City of Albuquerque

RE: DRAINAGE PLAN FOR THE PET DOCTOR (C-12/D3B2) ENGINEER'S STAMP DATED APRIL 2, 1992

THE PET DOCTOR
SUBJECT LOT 1-B, BLK 8, A.M. JOB NO. _____
BY FCA DATE 3-92 SHEET NO. _____ OF _____

SECTION A-A
1" = 10' 0"

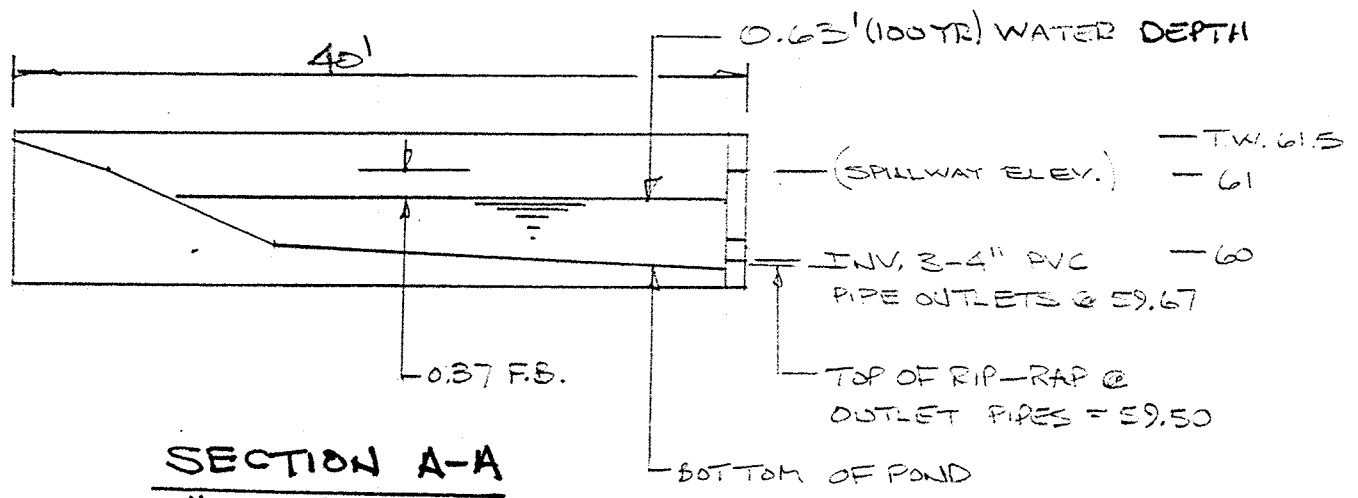
1. HYDRAULICS FOR 3-4" PVC PIPES. YOU ARE ALLOWED TO DISCHARGE ONLY 1.67 CFS" APR 2 1992

2. TYPICAL POND SECTIONS INCLUDES SPOT ELEVATIONS AND THE 100 YR. WATER SURFACE ELEVATION.
 (SEE ATTACHED DRAWING)

3. INCLUDE THE CALCULATIONS FOR THE EMERGENCY SPILLWAY.

SOLUTION: SOLVE FOR SINGLE 4" ϕ PIPE WHERE
 $Q = \frac{1.67 \text{ CFS}}{3} = 0.56 \text{ CFS}$

SELECT AN OUTFLOW PIPE FROM THE ORIFICE FORMULA THAT WILL YIELD THE ALLOWABLE OUTFLOW OF $> 0.56 \text{ CFS}$ UNDER A HEAD OF 1.0 FEET.

$$Q = C A \sqrt{2 g H} \quad \text{WHERE } C = 0.80 \text{ FROM TABLE 4-10, HANDBOOK OF HYDRAULICS KING AND FRATER, 1962}$$

SOLVING FOR A

$$A = \frac{Q}{C \sqrt{2 g H}} = \frac{0.56}{0.80 \sqrt{2(32.2)(1.0)}} = 0.087 \text{ FT}^2$$

$$\text{AREA OF 4" } \phi \text{ PVC PIPE} = 0.087 \text{ FT}^2$$

3 PIPE WILL THEREFORE RELEASE
 $3 \times 0.56 \text{ CFS} = 1.67 \text{ CFS}$
 UNDER ONE FOOT OF HEAD.

SOLUTION: SOLVING FOR A 'BRIDG CRESTED WEIR' DUE TO THE MINIMAL DEPTH.

$$Q = C B H^{3/2} \quad \text{WHERE } C = 2.7, B = 4', H = 0.30'$$

$$SF = \frac{0.50'}{0.30'} = 1.67$$

$$Q = (2.7)(4')(0.3')^{1.5}$$

$$= 1.77 > 1.67 (\text{TOTAL } Q_{100}) = \text{O.K.}$$

3-4" PVC PIPE
SLEEVE, 12" OC
INV = 59.6
POND CONTAINMENT WALL
TO HAVE A SINGLE 4'
WIDE BY 6" DEEP OVER-
FLOW WEIR CENTERED
OVER OUTLET PIPES
